80 Charlotte Street

— 05 Conclusion

This minor material amendment application seeks to complete the demolition of the original 1960's post office building due to the conditions of the existing structure. The additional demolition sought results in amendments to the facades which have been discussed at the pre-application stage with Camden officers.

Proposed Lower Ground Floor

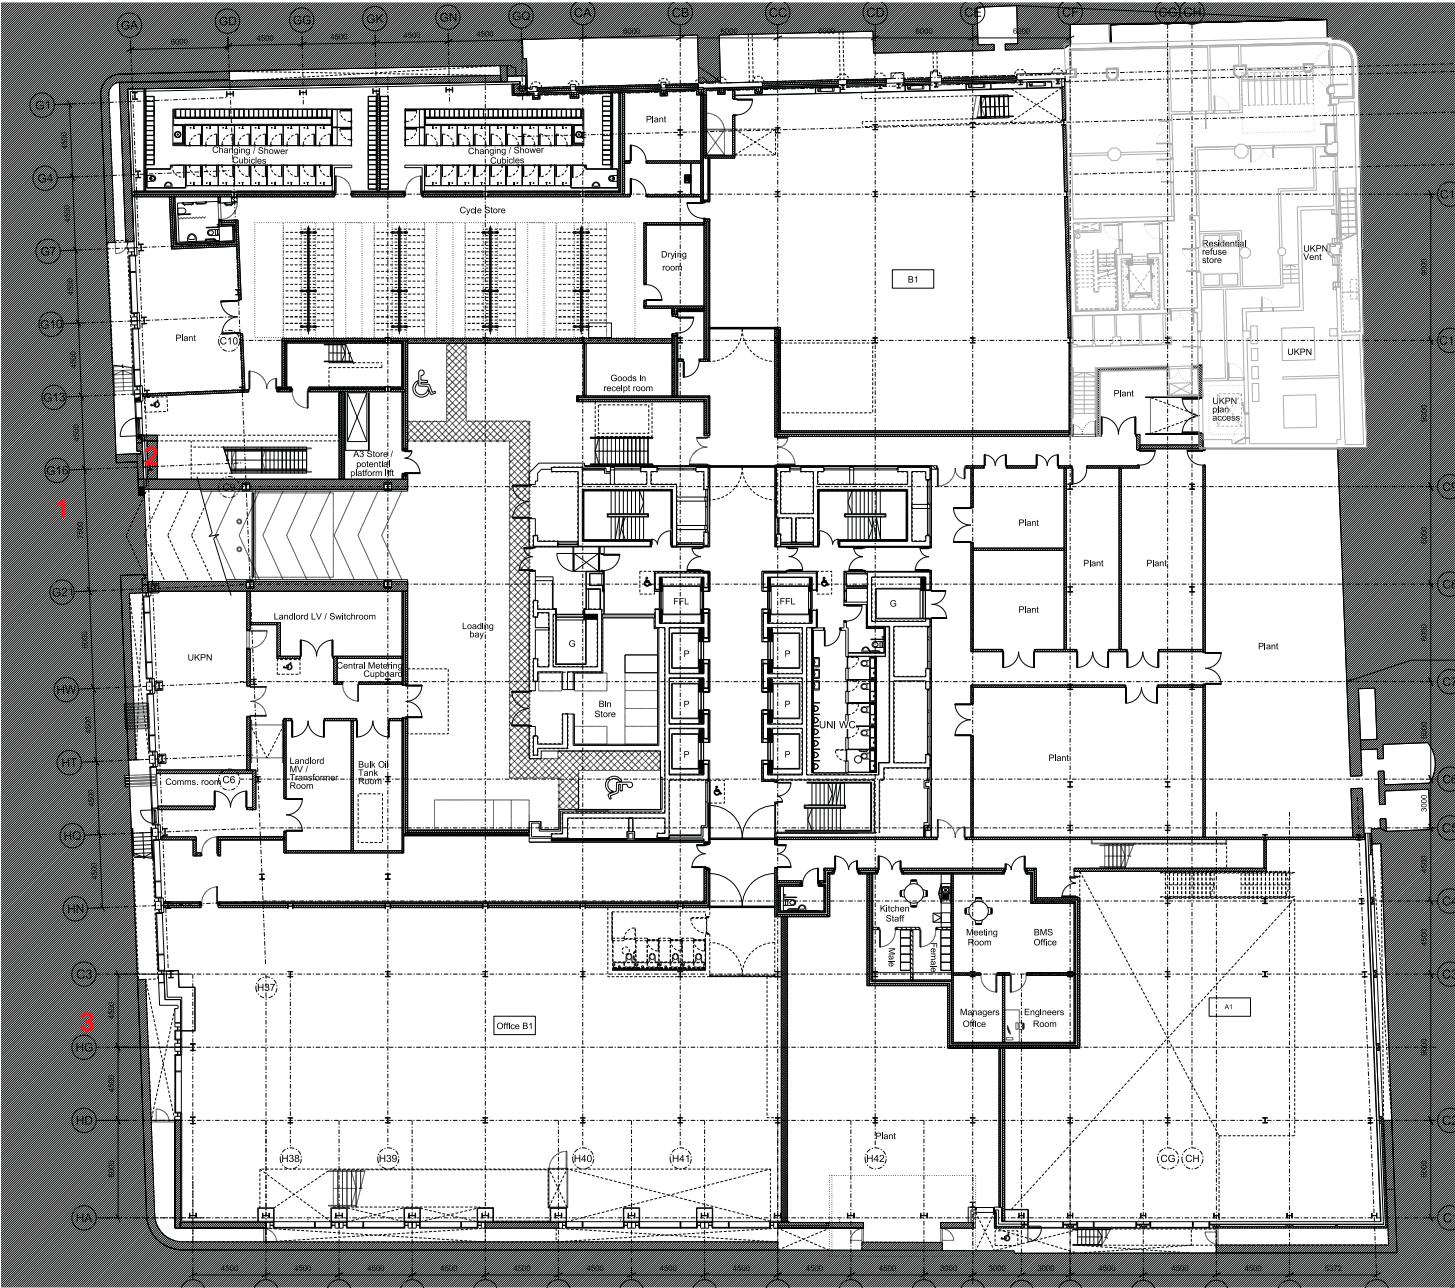
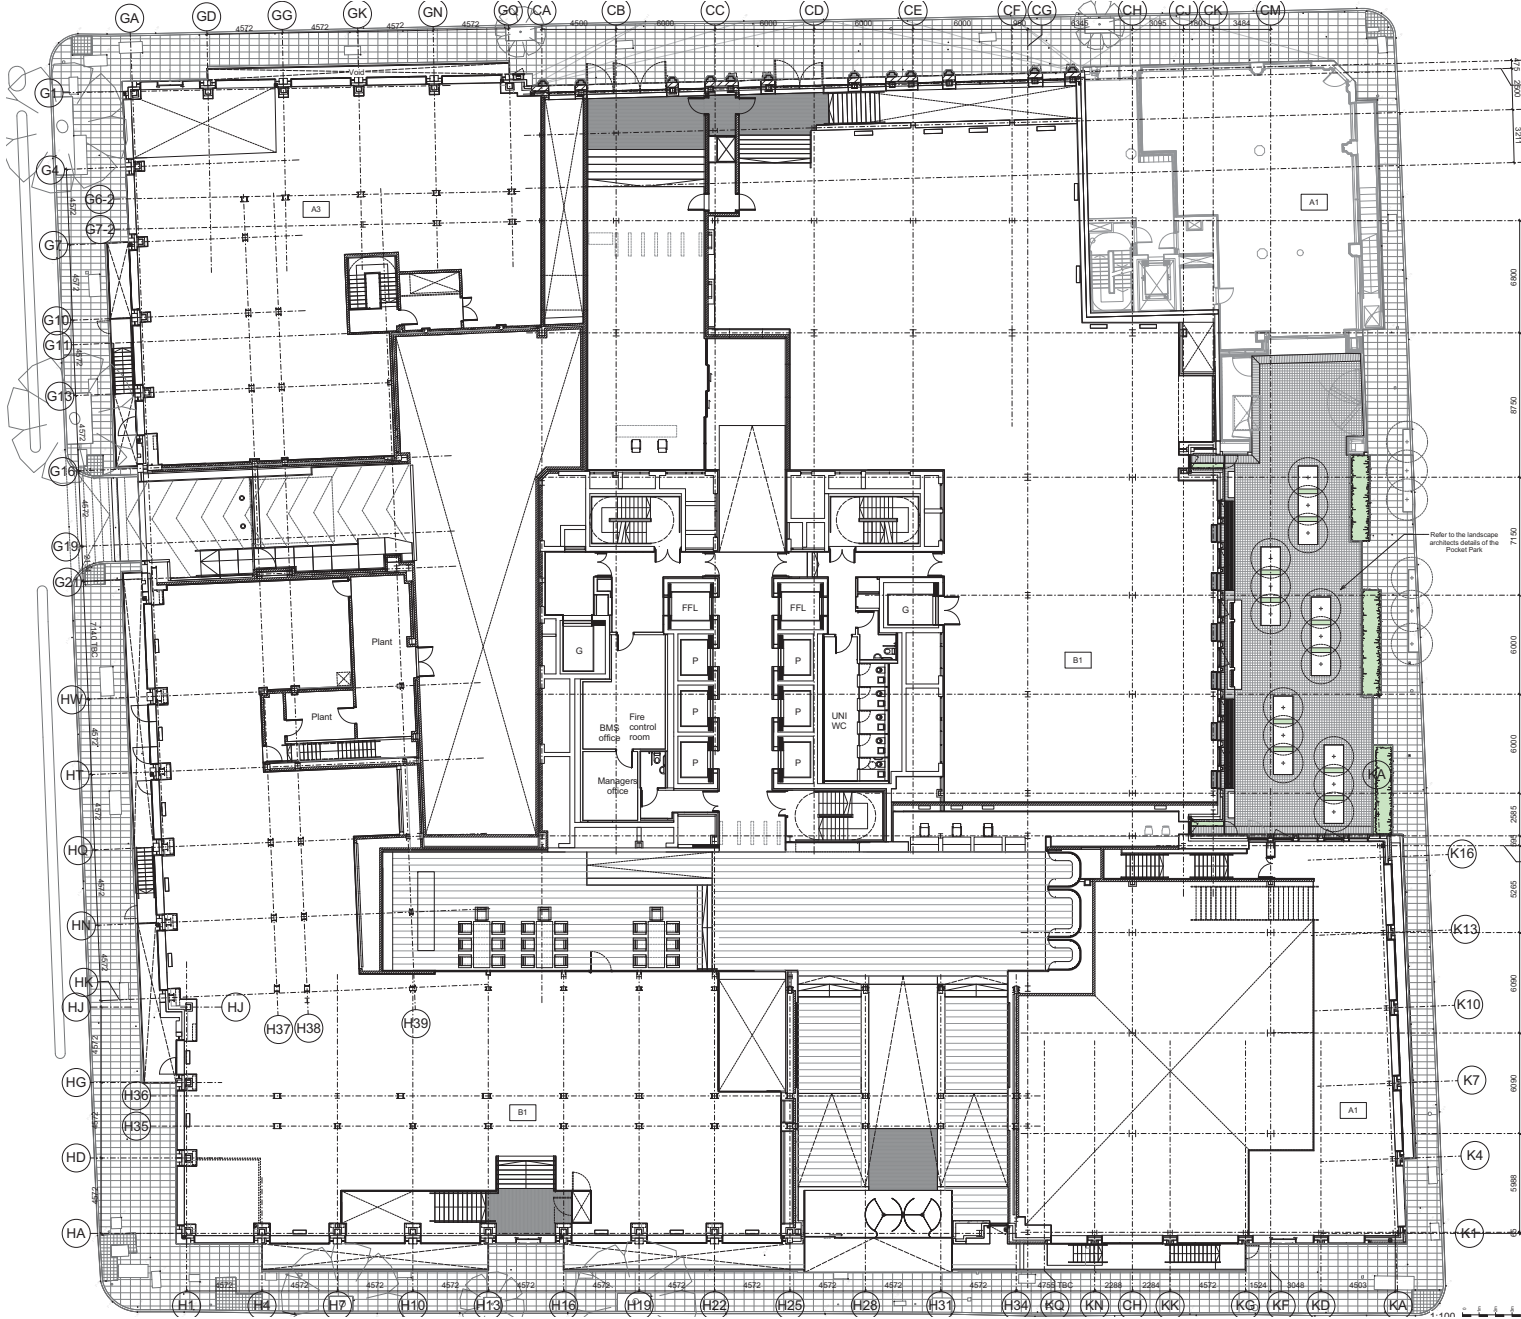
New Lower Ground floor plan indicating the new structure and reorganised spatial arrangement.

- 1. No change to the vehicular access point, servicing strategy and disable parking
- 2. No change to cycle provision except the access to the cycle store is now improved with a separate entrance rather than sharing the vehicular access ramp as consented. The cycle store has also been consolidated within one part of the Lower Ground Floor. This will require a resubmission of details under Condition 5.
- 3. The extent of the light wells has been slightly increased to bring more light down to the lower ground spaces.

New Ground floor plan

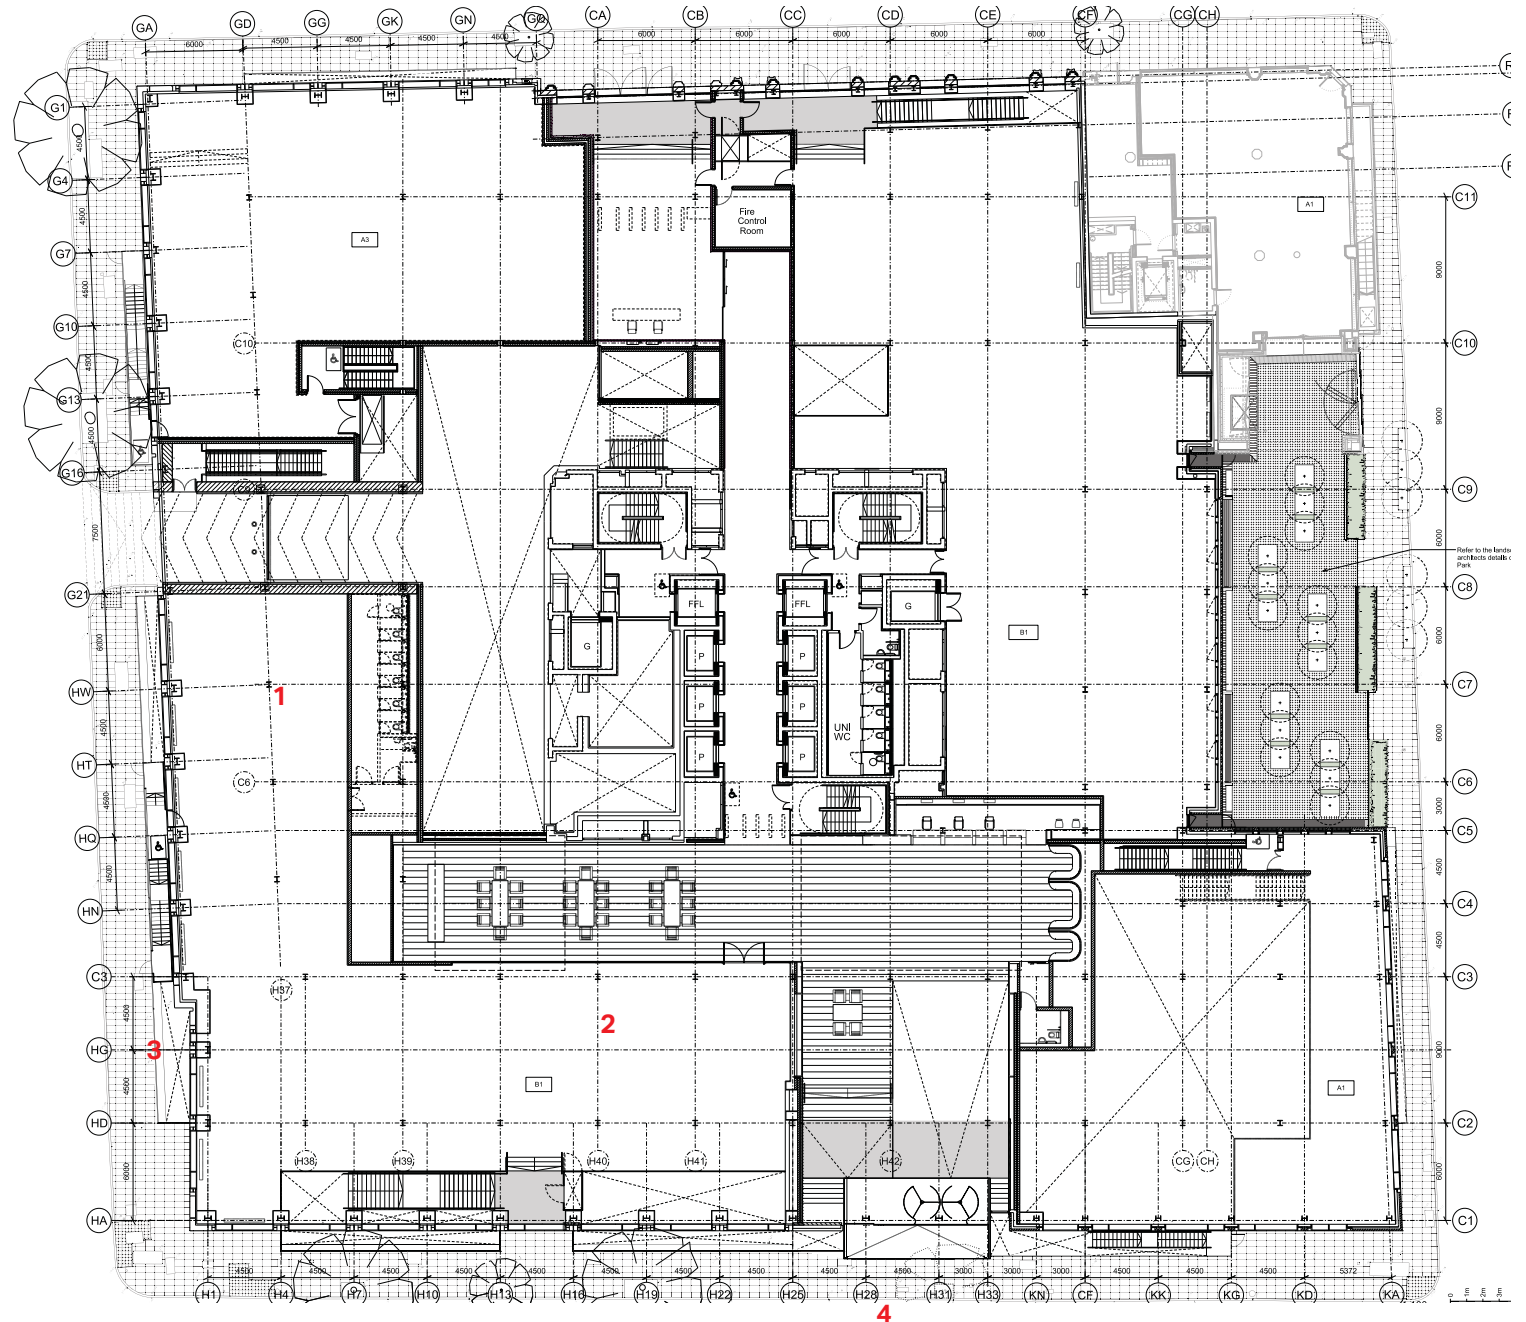
1. Reorganised spatial arrangement
2. Revised internal structure.
3. Revised lightwell extent
4. No change to entrance locations apart from a slight move of the main entrance on Charlotte Street

First floor plan

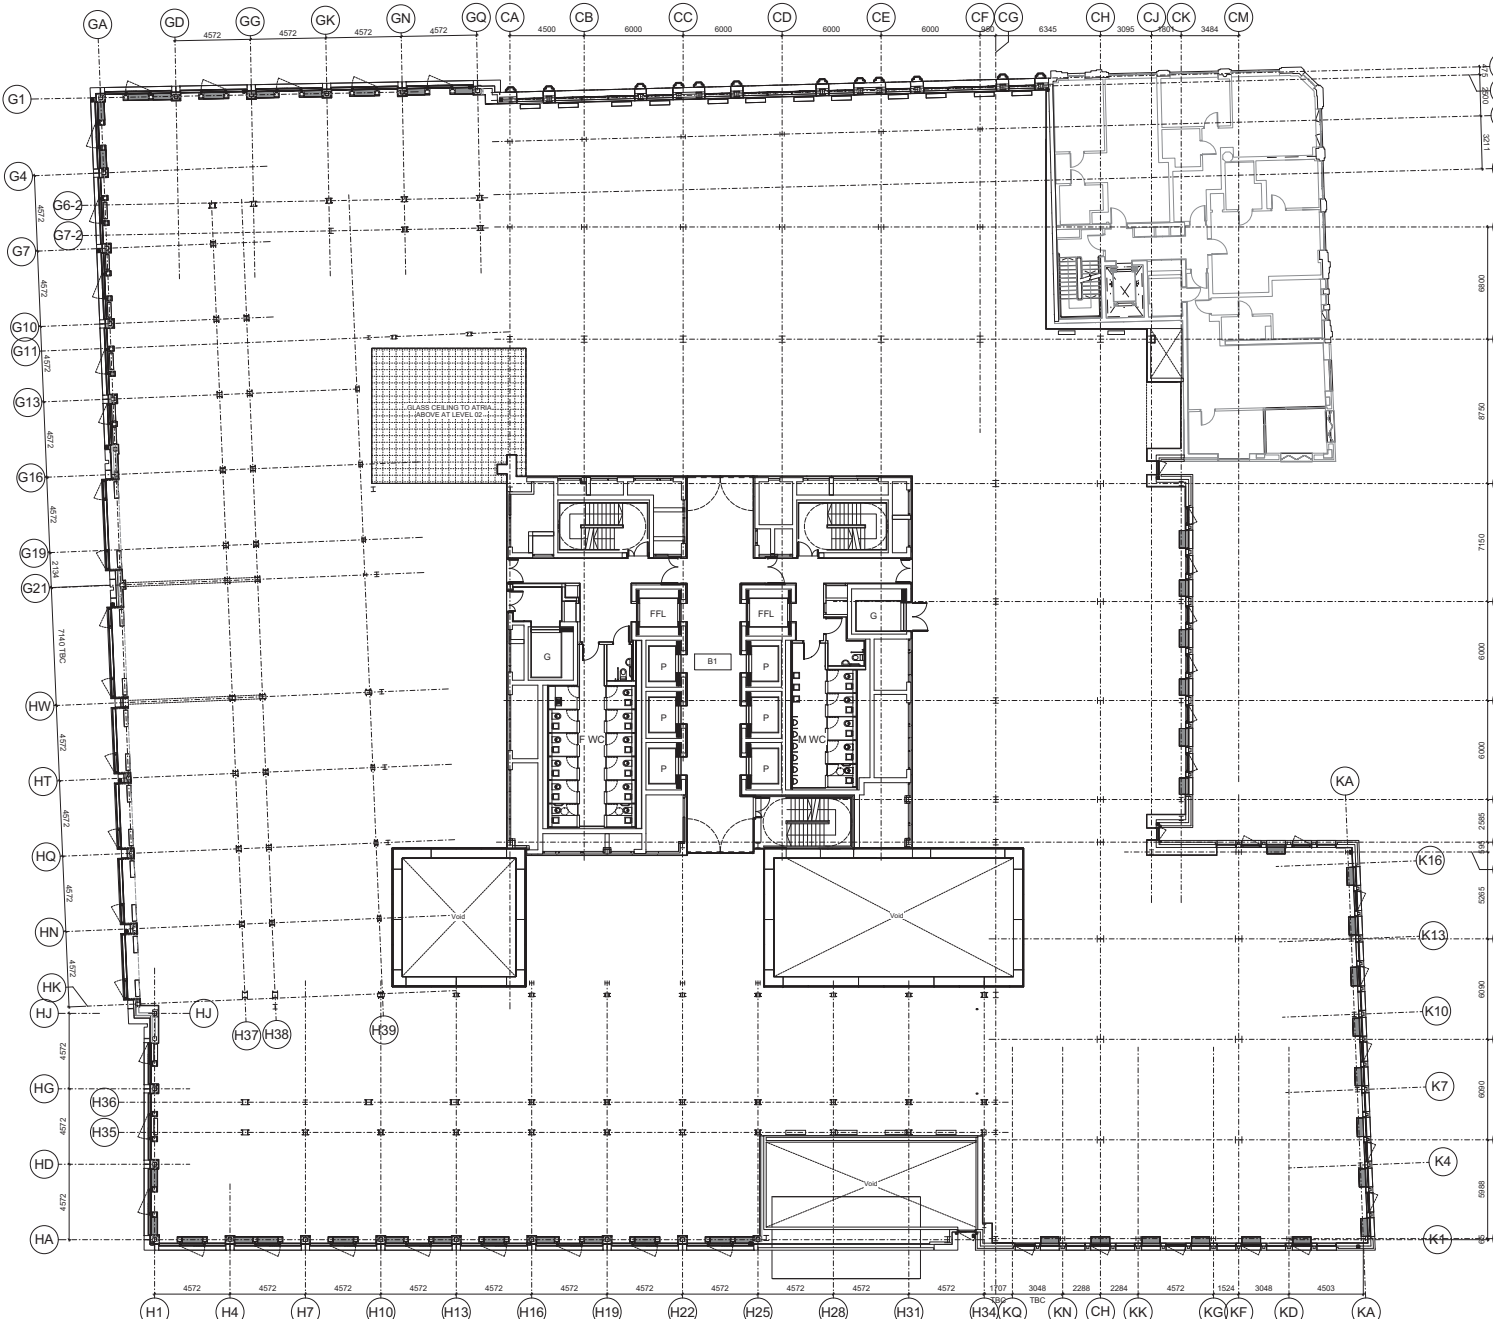
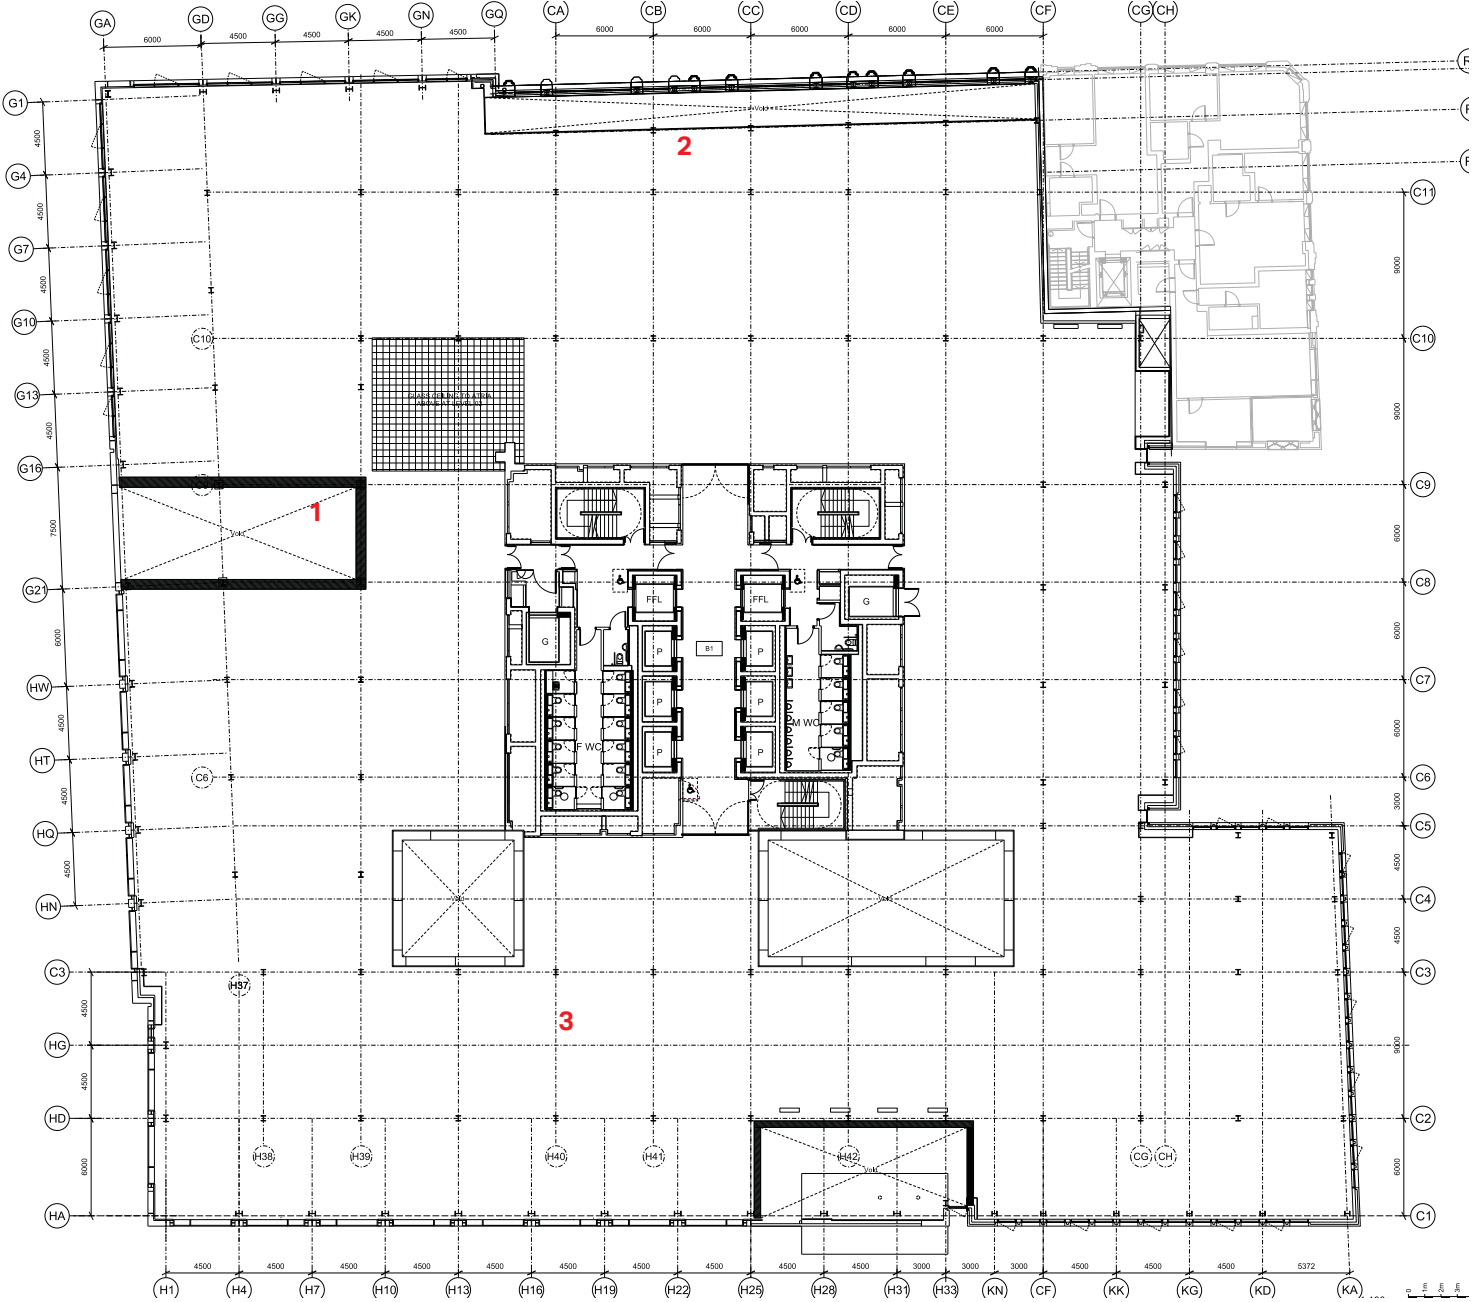
- 1. Introduction of a void over the consented service ramp due to the new levels
- 2. New void introduced along retained façade to allow for the internal spaces to be resolved.
- 3. Revised internal structure
